Docket Item # 9
BAR CASE # 2009-0145

BAR Meeting
July 29, 2009

ISSUE: Addition and Alterations
APPLICANT: Victoria Sackett by Robert Shaw
LOCATION: 922 South Alfred Street
ZONE: RM/Residential

BAR CASE #2009-0144 & 0145 7/29/2009

Figure 7. Proposed south elevation and trim/post details.

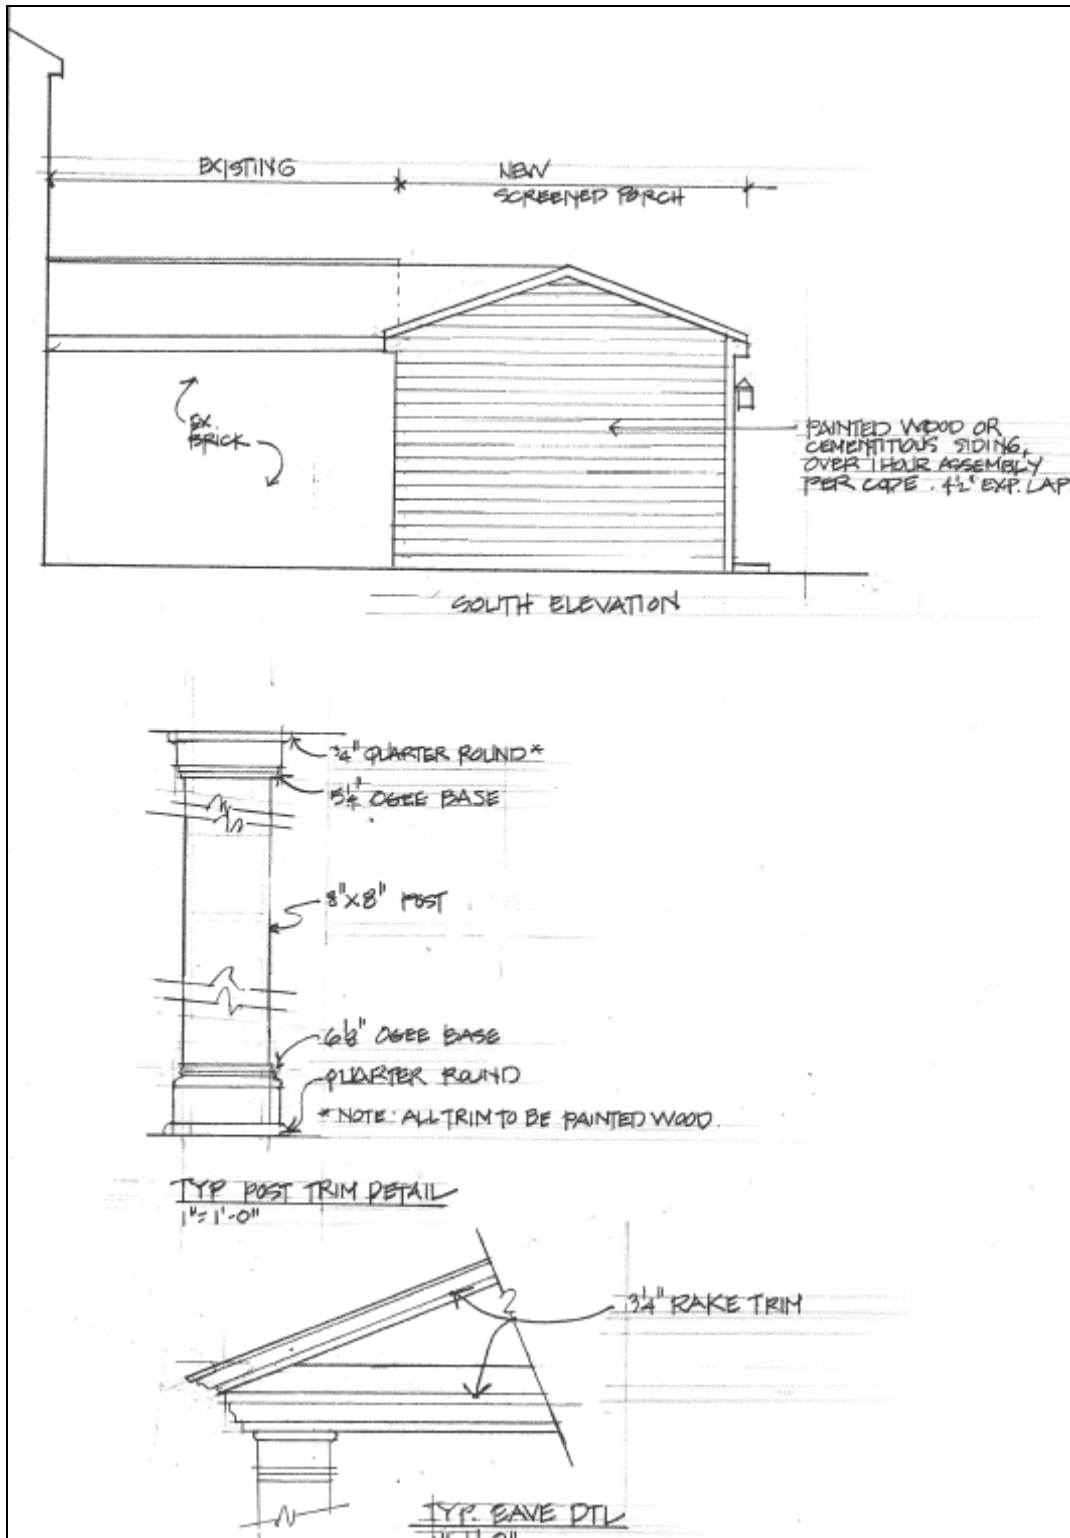
1. That if cementitious siding is used on the south elevation that the nails not show in the installation of the siding and that smooth (non-simulated wood grain) siding be installed.
